2810 WELTON STREET PROPOSED MIXED USE PROJECT

28TH STREET MATERIAL AND DETAILS SUBMITTAL REVISION #1

The overall building length was change from 98 feet to 88 feet to comply with parking requirements and site circulation which occurs on the south side (alley). The City requires 2 feet right of way dedication for the alley to be widen. The overall building design and character remain similar. The 01 Main Level is change to Eating and Drinking Establishment. The 02 Second Level is change to Dance Studio (Arts and Entertainment).The Material and Details with Specifications remain the same.

① NORTH ELEVATION
1/8" = 1'-0"

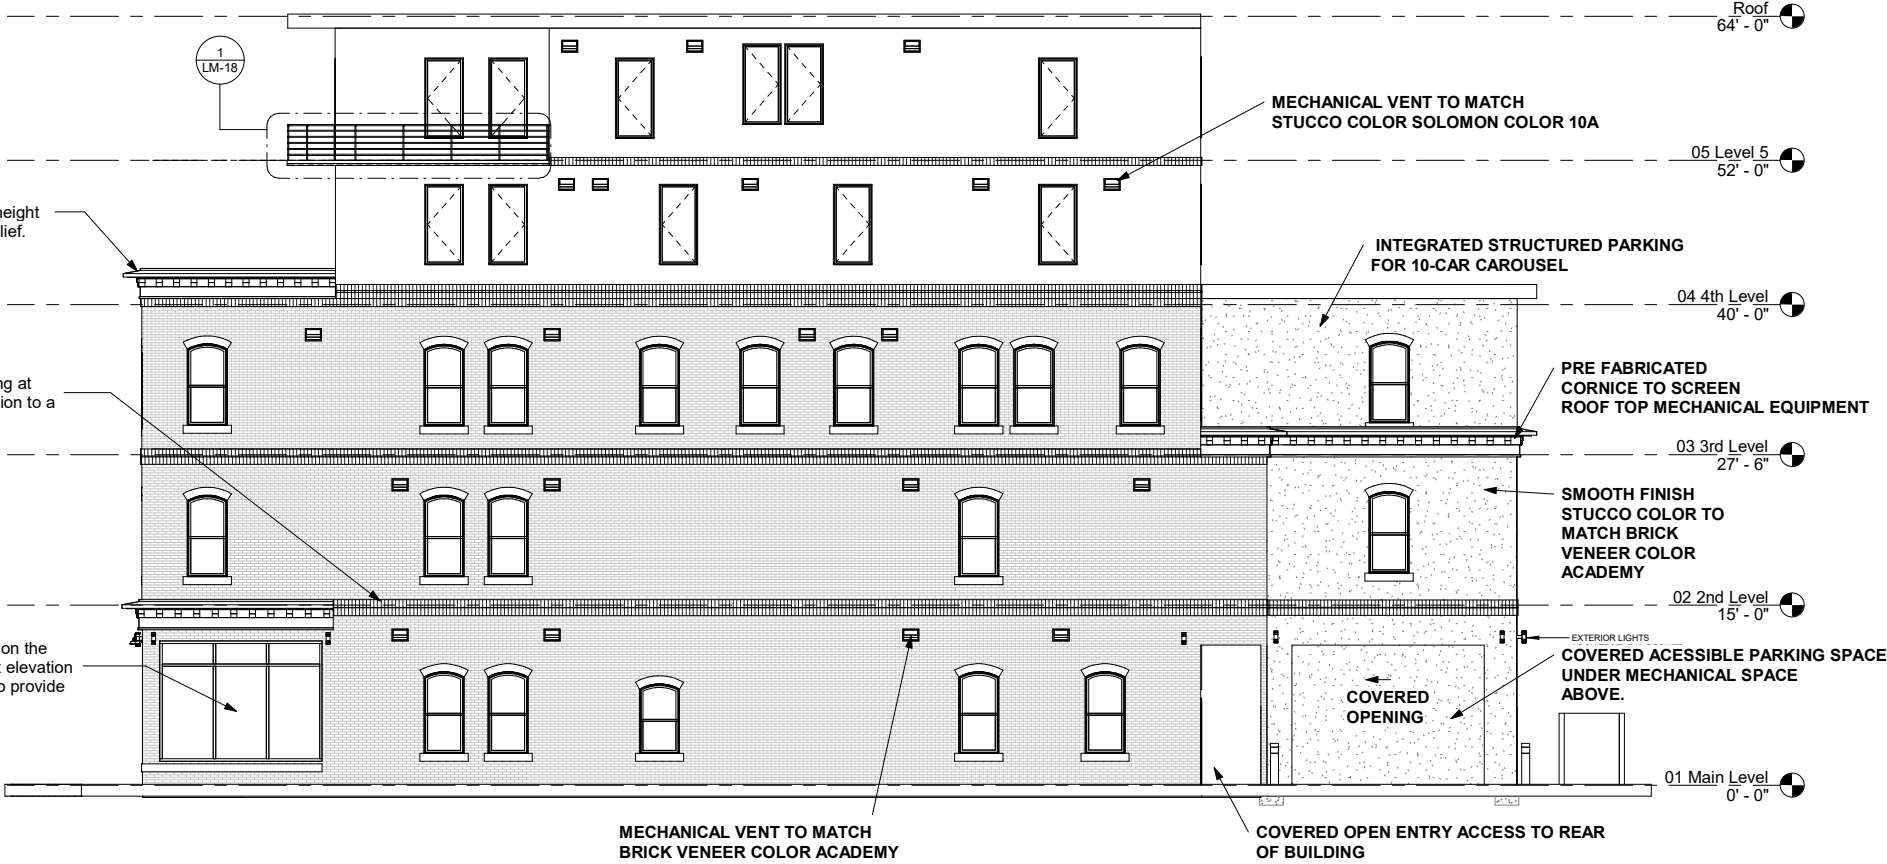
CONDITION 2:
Reduce height of upper story
stair tower on front elevation
to match adjacent 64' height.

CONDITION 1:
Alignment of upper story
center windows on front
elevation to 1st floor entry.

CONDITION 7:
Extend the third floor cap in height
and depth to provide more relief.

CONDITION 4:
Convert the projecting banding at
first floor level on west elevation to a
flat brick articulation.

CONDITION 3:
Wrap the storefront windows on the
front elevation along the west elevation
for a minimum of 15' length to provide
additional articulation.

STREETSCAPE STUDY WITH 2801 WELTON STREET

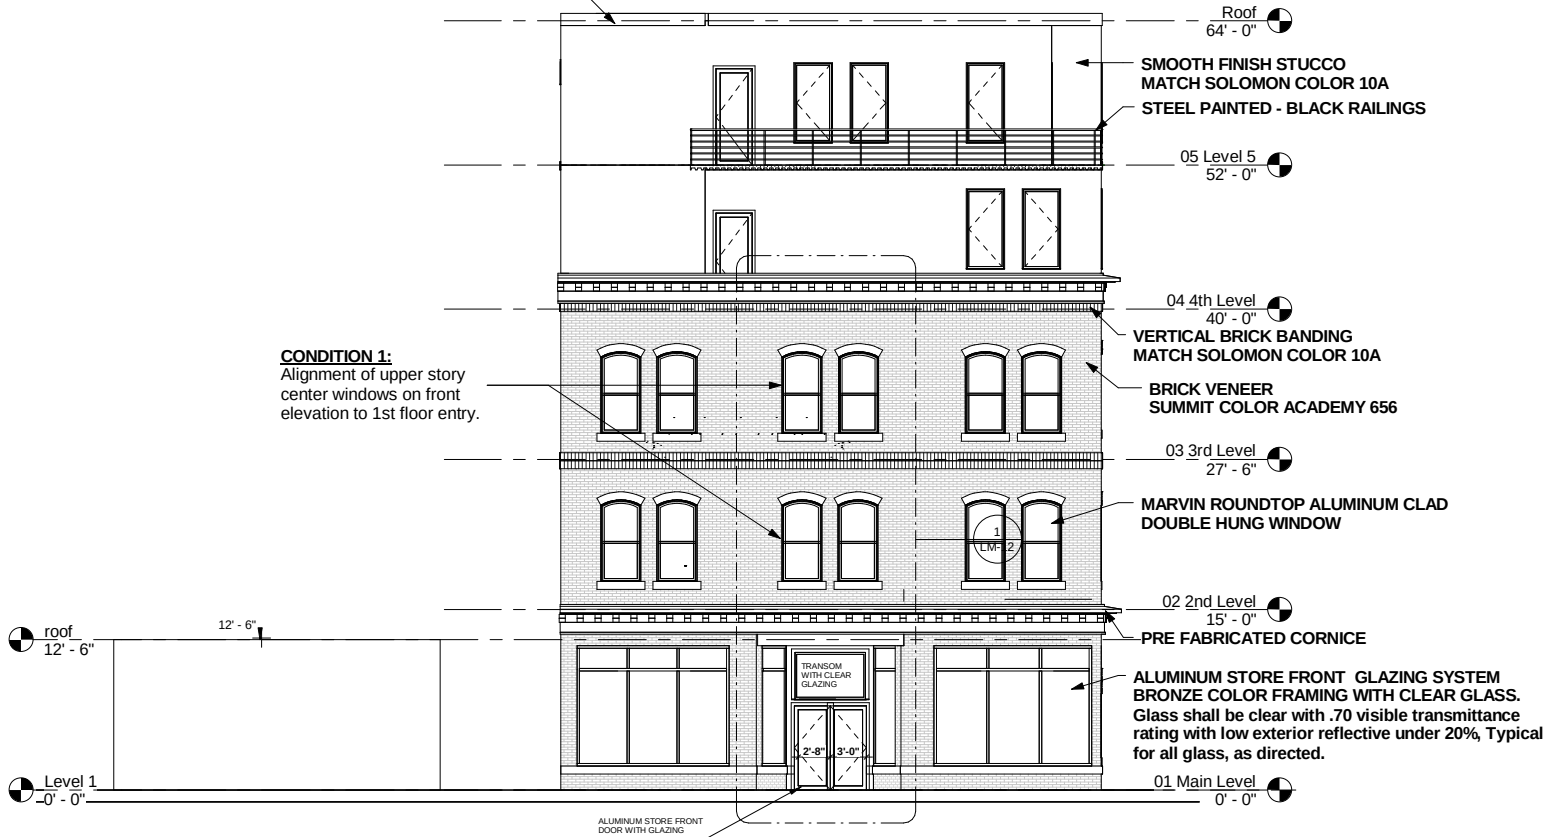
CONDITION 2:
Reduce height of upper story stair tower on front elevation to match adjacent 64' height.

CONDITION 1:
Alignment of upper story center windows on front elevation to 1st floor entry.

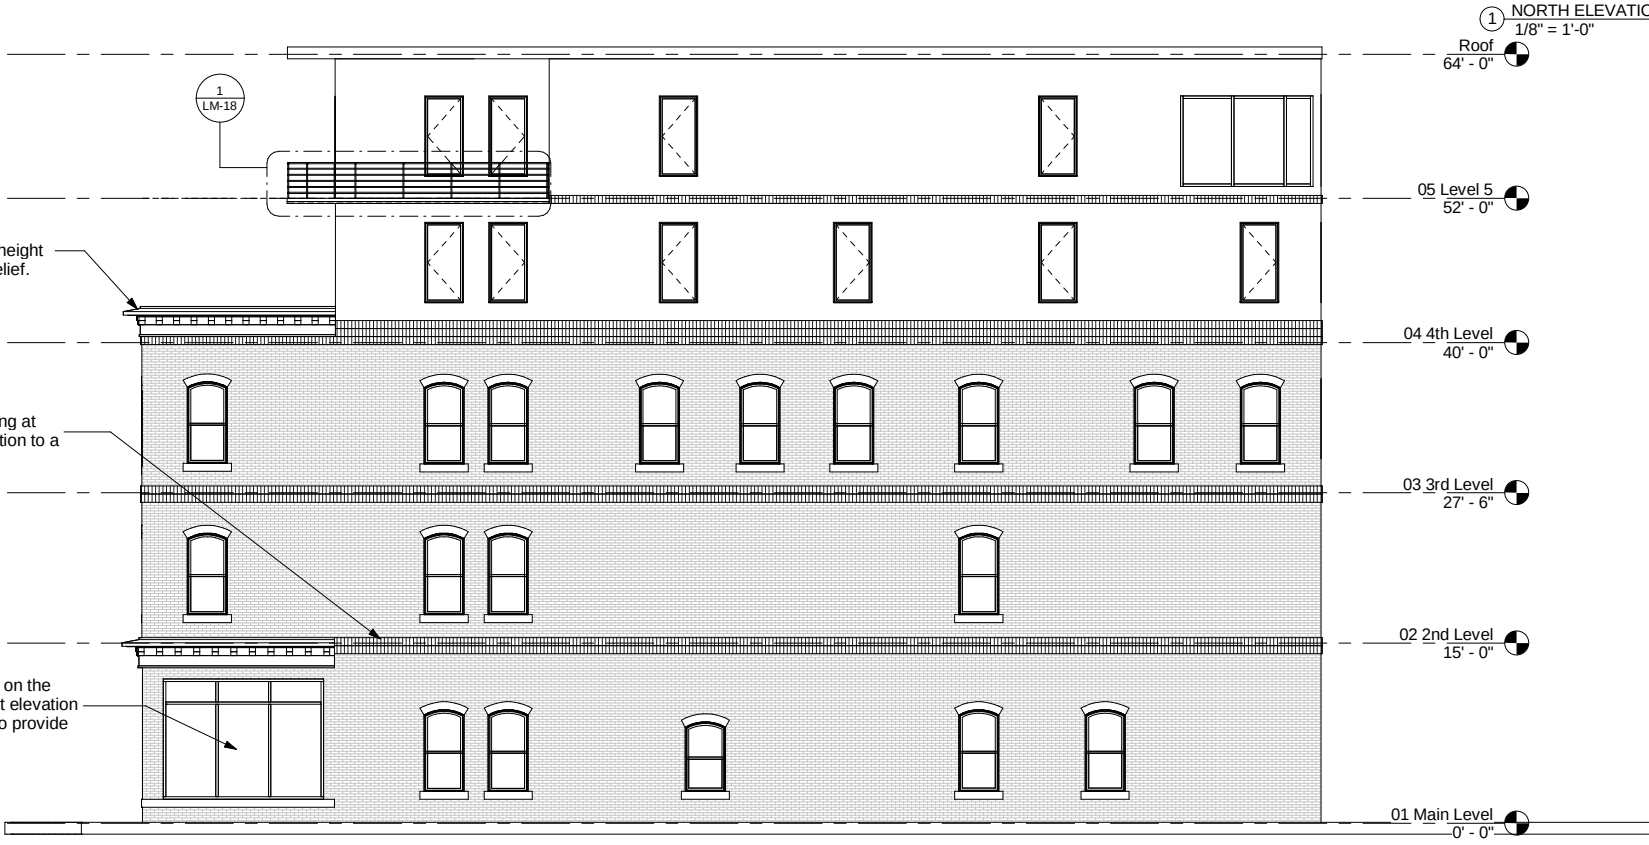
CONDITION 7:
Extend the third floor cap in height and depth to provide more relief.

CONDITION 4:
Convert the projecting banding at first floor level on west elevation to a flat brick articulation.

CONDITION 3:
Wrap the storefront windows on the front elevation along the west elevation for a minimum of 15' length to provide additional articulation.

CONDITION 2:
Reduce height of upper story stair tower on front elevation to match adjacent 64' height.

CONDITION 1:
Alignment of upper story center windows on front elevation to 1st floor entry.

1 EAST ELEVATION
1/8" = 1'-0"

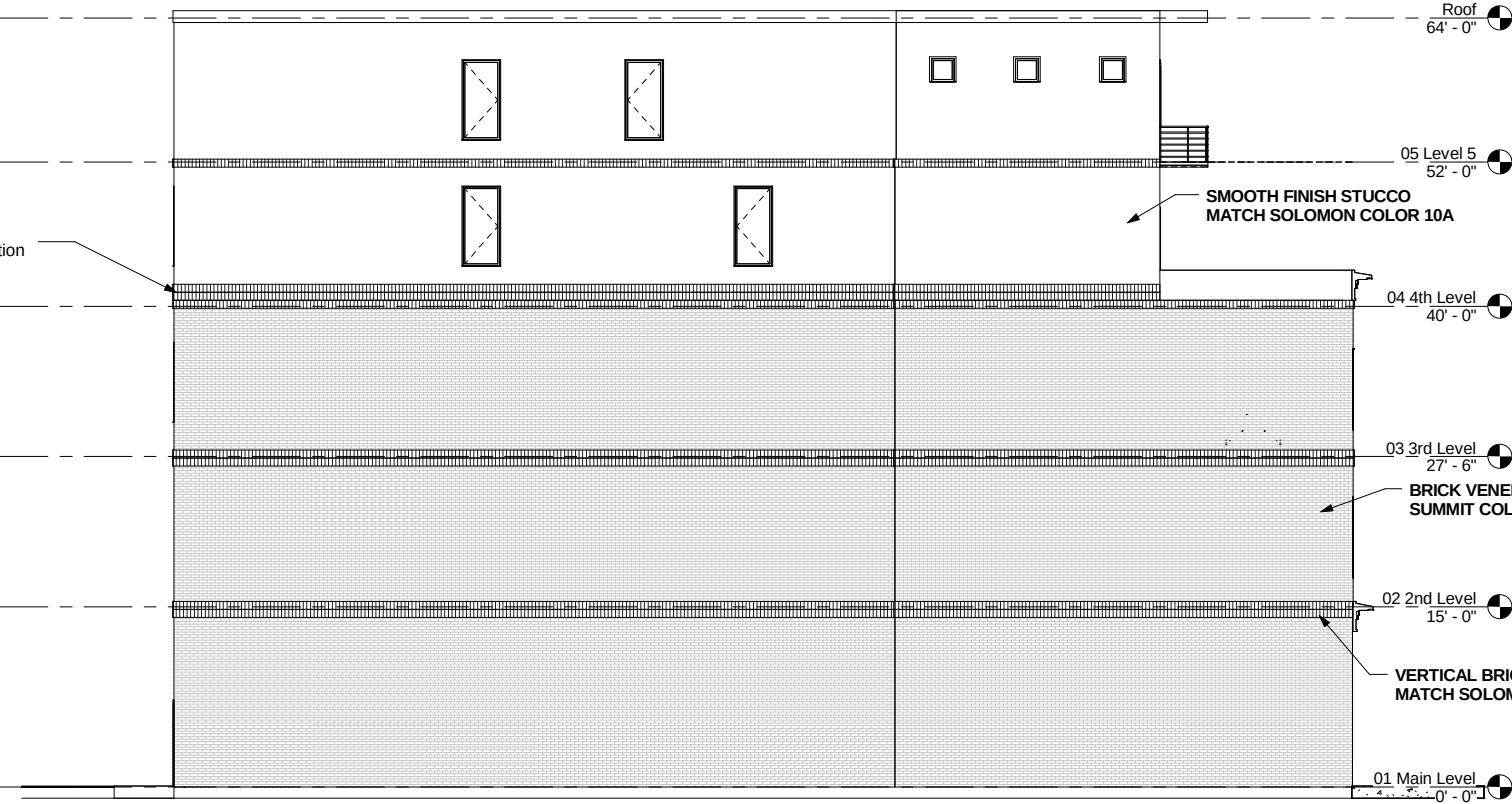
CONDITION 5:
Add additional flat
relief to east elevation
wall.
